**SUSQUEHANNA STEAM ELECTRIC STATION
PROPOSED LICENSE AMENDMENT NO. 285
FOR UNIT 1 OPERATING LICENSE NO. NPF-14
AND PROPOSED LICENSE AMENDMENT NO. 253
FOR UNIT 2 OPERATING LICENSE NO. NPF-22
EXTENDED POWER UPRATE APPLICATION
REGARDING CHANGE TO
TECHNICAL SPECIFICATION SR 3.7.1 –
RESIDUAL HEAT REMOVAL SERVICE WATER
(RHRSW) SYSTEM
AND THE ULTIMATE HEAT SINK (UHS)
PLA-6266**

**Docket Nos. 50-387
and 50-388**

The purpose of this letter is to revise the proposed change to Technical Specification (TS) 3.7.1 contained in Reference 1 based on discussions held with the NRC staff on August 23, 2007.

TS 3.7.1 Revision Basis

Minimum Heat Transfer Analysis
Large Spray Array Valve Inoperable Case

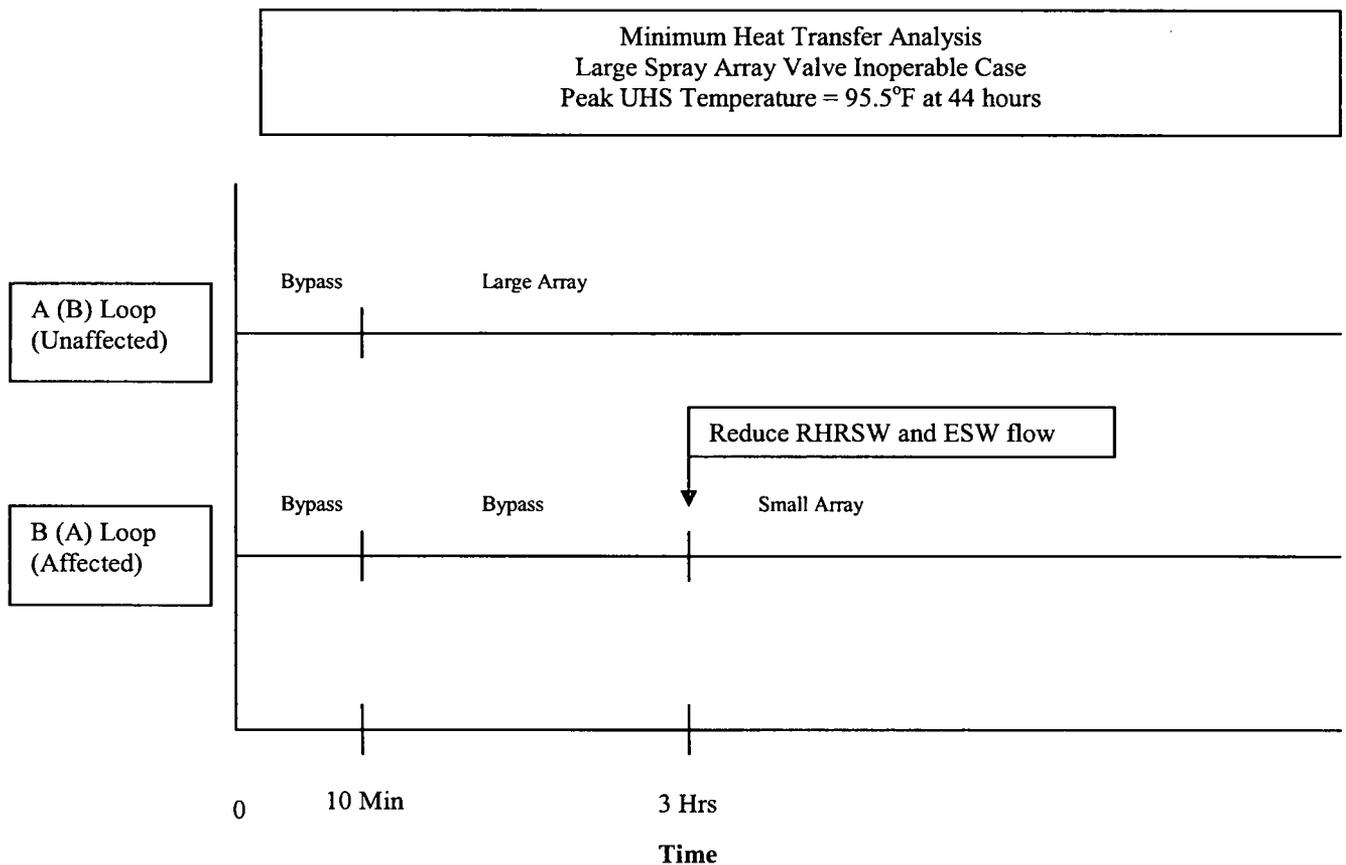
For this case, a large spray array valve is assumed to be inoperable in the closed position ("affected" loop). Heat is rejected to the UHS through both bypass lines at the beginning of the transient. On the unaffected loop, the large spray array valve is opened and the motor operated bypass valve is closed at 10 minutes to establish spray cooling. On the affected loop, flow continues through the bypass line for three hours. At three hours, RHRSW and ESW flow are reduced on the affected loop, the small spray array valve is opened and the motor operated bypass valve is closed to establish spray cooling. Spray cooling using a large spray array on one loop and a small spray array on the other loop continues for the balance of the transient.

Minimum Heat Transfer Analysis
One Loop Inoperable Case

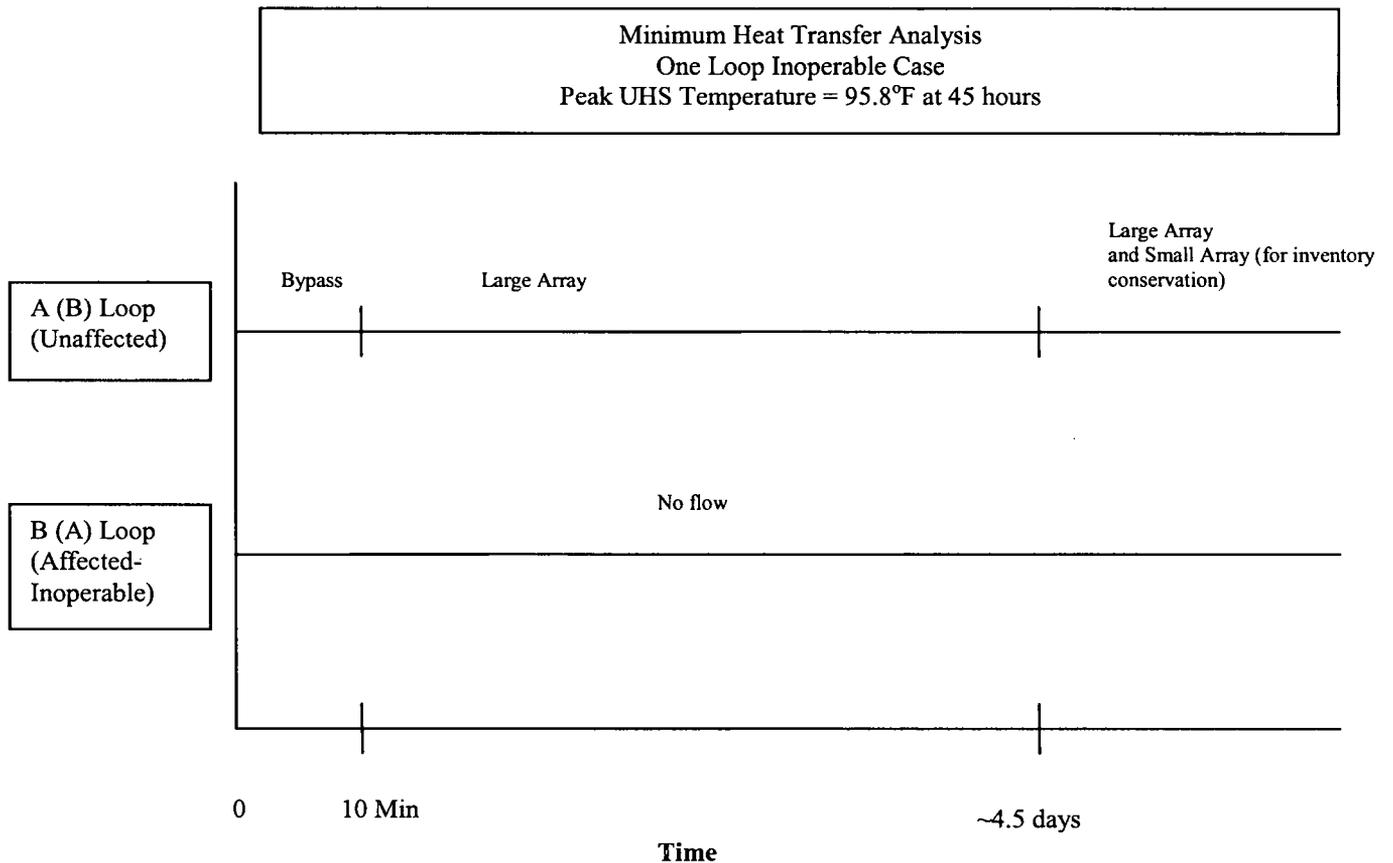
For this case, an entire loop of RHRSW and ESW is assumed to be inoperable ("affected" loop). No flow is assumed to exist in the affected loop for the entire transient. On the unaffected loop, heat is rejected to the UHS through the bypass line at the beginning of the transient. At 10 minutes, the large spray array valve is opened and the motor operated bypass valve is closed to establish spray cooling. Spray cooling using the large spray array continues until the small spray array valve is opened in order to conserve water inventory. Spray operation continues using both spray arrays in the same loop for the balance of the transient.

Maximum Water Loss Case
Peak UHS Temperature = 66.7°F at 7 days 3 hrs
Remaining Inventory = 0.97E+6 Gallons at 30 Days

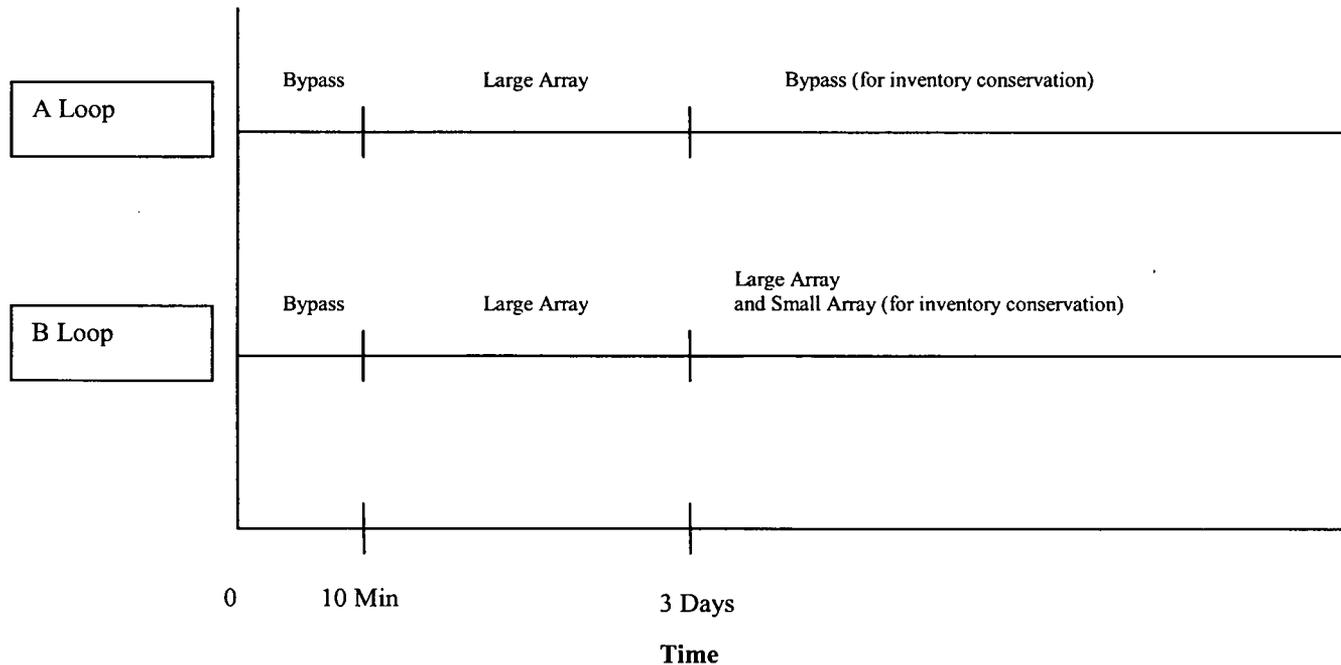
All equipment is assumed to be OPERABLE for this case. Heat is rejected to the UHS through both bypass lines at the beginning of the transient. At 10 minutes, the large spray array valves are opened and the motor operated bypass valves are closed to establish spray cooling on both loops. Spray operation continues on both loops using the large spray arrays until actions are taken to reduce spray evaporation and drift losses. These actions involve the use of the small spray array on one loop (in addition to the large spray array) and the use of the bypass line on the other loop (no sprays). Under worst case conditions, these actions will take place in approximately 3 days. Operation will continue in this configuration for the balance of the transient.
